SERVICE LETTER

No. SL-AG-118

Relocating Engine Control Hardware to Improve
Engine Response

S2R-H80

Figure 118-1

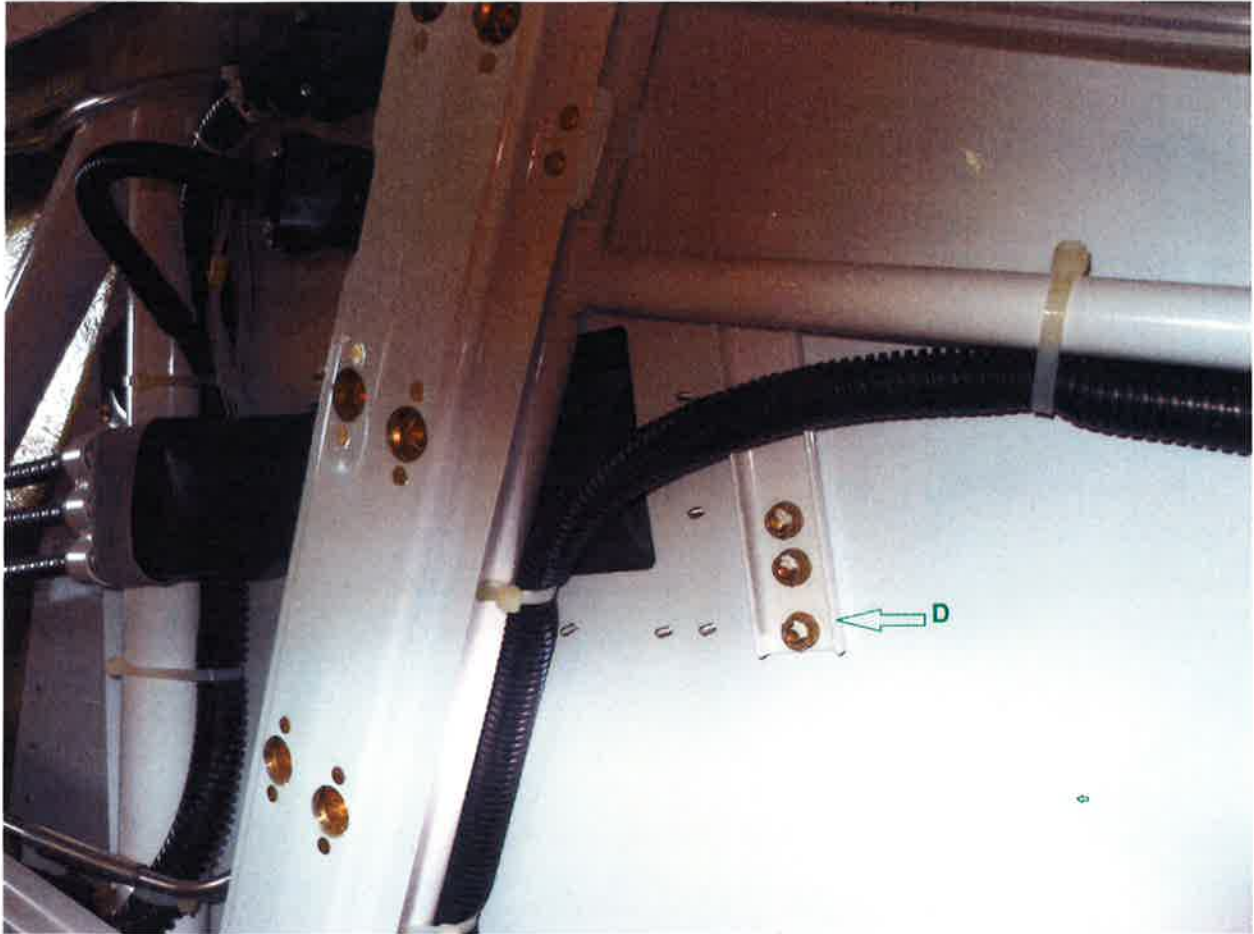
- 7-3.1 DISCONNECT MOUNTING BRACKET C AND BRACKET SUPPORT CHANNEL D. RETAIN HARDWARE FOR LATER USE.

7-3.2 MODIFY BRACKET SUPPORT CHANNEL **D** BY DRILLING ONE HOLE CENTERED WITH EXISTING HOLES AND APPROXIMATELY 0.55 INCHES ABOVE THE TOP HOLE. Ø #10.

Figure 118-3

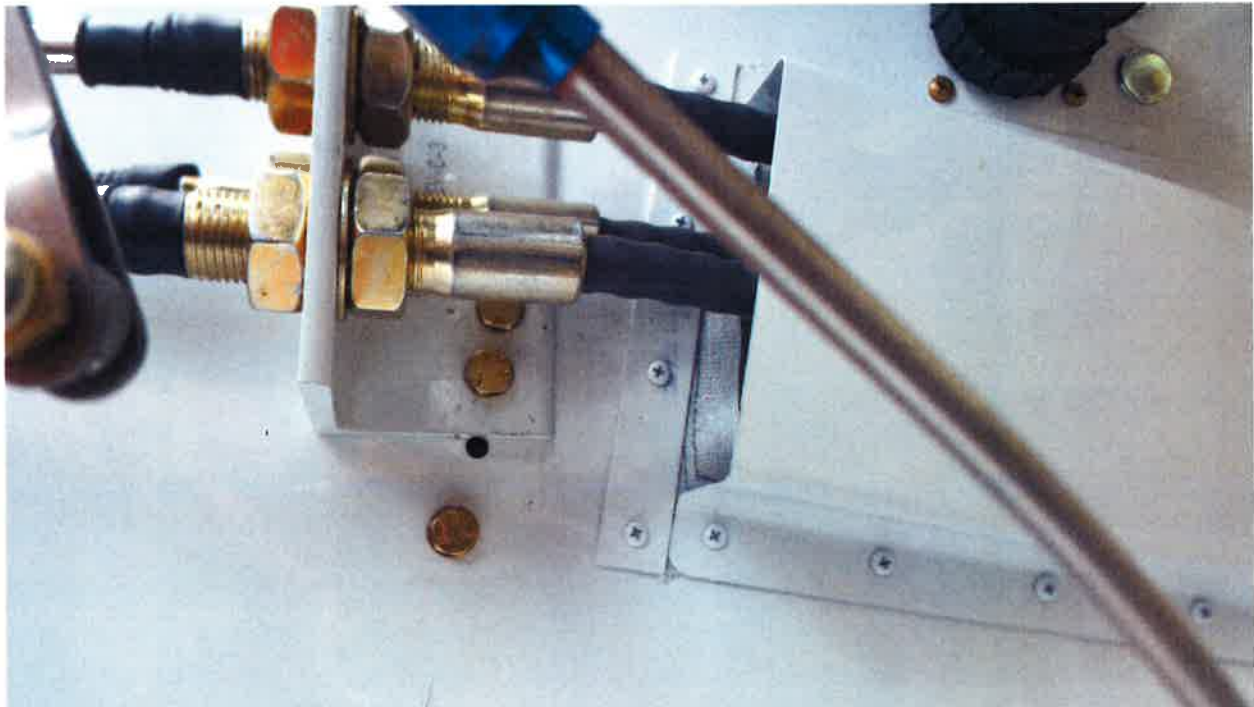
- E Disconnect this control cable from the Throttle Lever and label it as Throttle for reassembly.
- F Disconnect this control cable from the Prop Lever and label it as Prop.
- G The Fuel Control Lever attachment does not change.

Figure 118-4

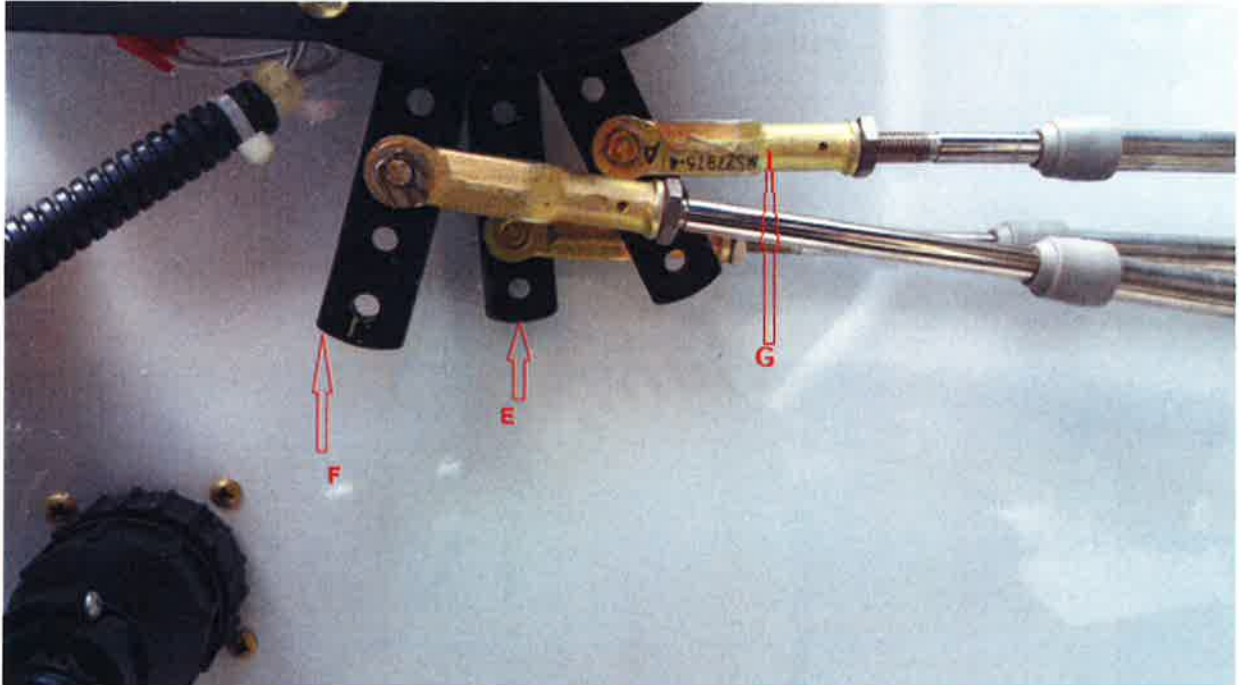
Desired configuration after step 7-3 of this document is completed. Notice empty hole and bottom bolt remains in the same place.

7-5.1 ENSURE THAT CONTROL CABLES CONFORM TO THE CONFIGURATIONS SHOWN BELOW AFTER RECONNECTION TO QUADRANT.

- E Reconnect to the Throttle Lever
- F Reconnect to the Prop Lever
- G The Fuel Control Lever Connection Does not change.
